**COMMUNITY DEVELOPMENT
DEPARTMENT REPORT**

HEARING DATE: 6/23/2026
 TO: Mayor & City Council
 FROM: Sonya Allen, Associate Planner
 208-884-5533
 sallen@meridiancity.org
 APPLICANT: Anthony Swanson, Hillside Architecture
 SUBJECT: SHP-2026-0004
 Midgrove Plaza
 LOCATION: 1450 E. Franklin Road, in the SE 1/4 of Section 7, T.3N., R.1E.

Short plat consisting of two (2) building lots on 12.84 acres of land in the C-G and I-L zoning districts for Midgrove Plaza Subdivision.

A. Short Plat (date: 4/18/2026)

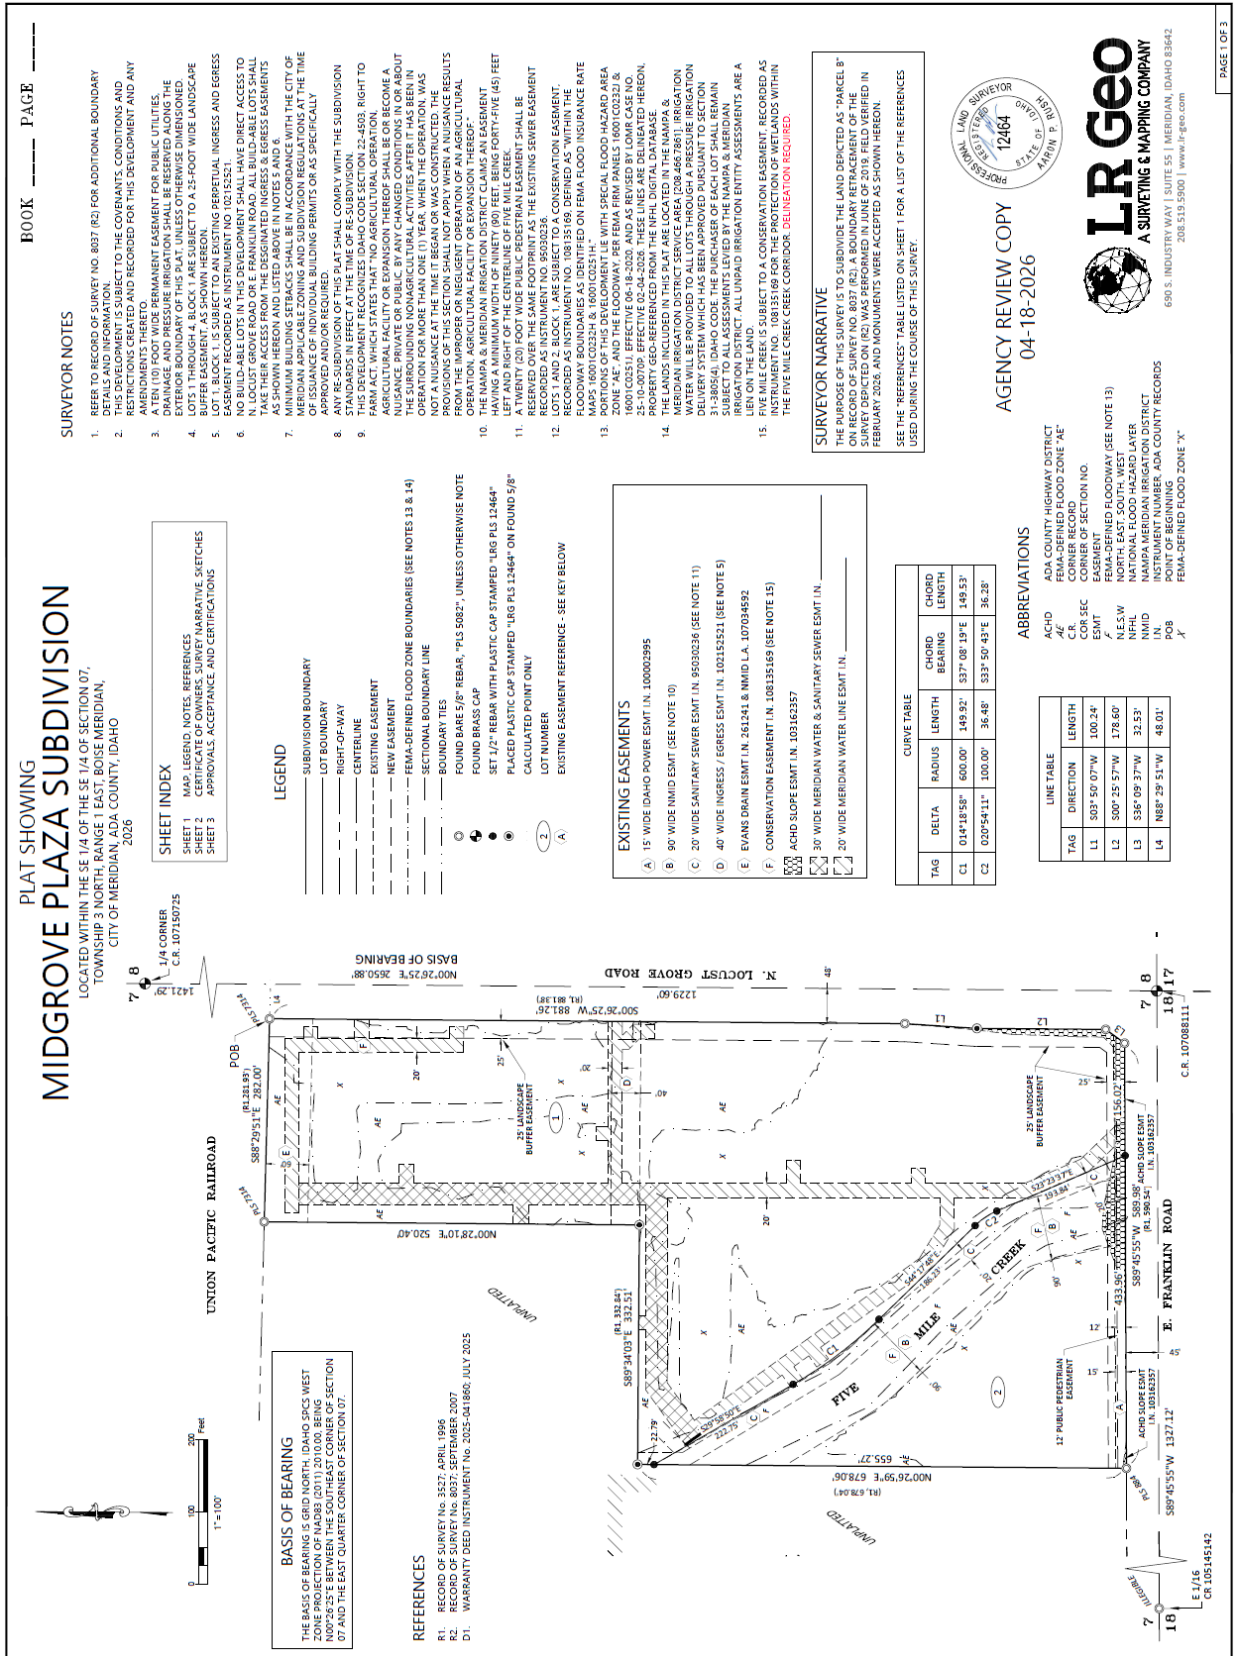
2. The plat submitted for City Engineer signature shall include the following revisions:
 - a. Depict a 25' wide street buffer along E. Franklin Rd. and N. Locust Grove Rd., measured from back of sidewalk if the existing sidewalk is proposed to remain or back of curb if the sidewalk is proposed to be replaced with a detached sidewalk. If the existing Idaho Power easement along Franklin Rd. doesn't allow trees/shrubs and encumbers the entire buffer, a minimum 5' wide area shall be provided outside the easement to plant trees/shrubs.

- b. Depict and dimension the existing Idaho Power easement along E. Franklin Rd.
 - c. Structures and improvements shall not encroach in existing easements on the site unless approved by the easement holder(s) through a license agreement.

- d. Depict a cross-access/ingress-egress easement to the properties to the west (i.e. Parcels S1107449990 & S1107449111) on both the north and south sides of the Fivemile Creek; and between Lots 1 and 2, Block 1. If the existing cross-access easement (Inst. #102152521) provides for cross-access/ingress-egress to the property to the west, submit a copy of the copy of the recorded easement for verification.

- e. Depict a minimum 14' wide public pedestrian access easement for the future multi-use pathway along the east side of the Fivemile Creek per Park's Dept. requirements. The easement may overlay required utility easements along the creek, but shall be recorded separately from the plat. Another 10' wide public pedestrian access easement shall be depicted behind the sidewalk along W. Franklin Rd. as far as the creek to allow for a future detached sidewalk connection to the proposed Fivemile Creek pathway.

- f. Surveyor Notes:
 - i. Note #4: "Lots 1 through 4 2, Block 1 . . ." Buffer shall be measured from back of existing sidewalk or back of curb if the sidewalk is to be replaced with a detached sidewalk.

- ii. Include a note stating access via Franklin Rd. is prohibited.
 - g. Existing Easements:
 - i. Include the recorded instrument number for the 30' wide Meridian water and sewer easement.

- ii. Include the recorded instrument number for the 20' wide Meridian water line easement.
3. The landscape plan submitted with the plat for City Engineer signature shall include the following revisions:
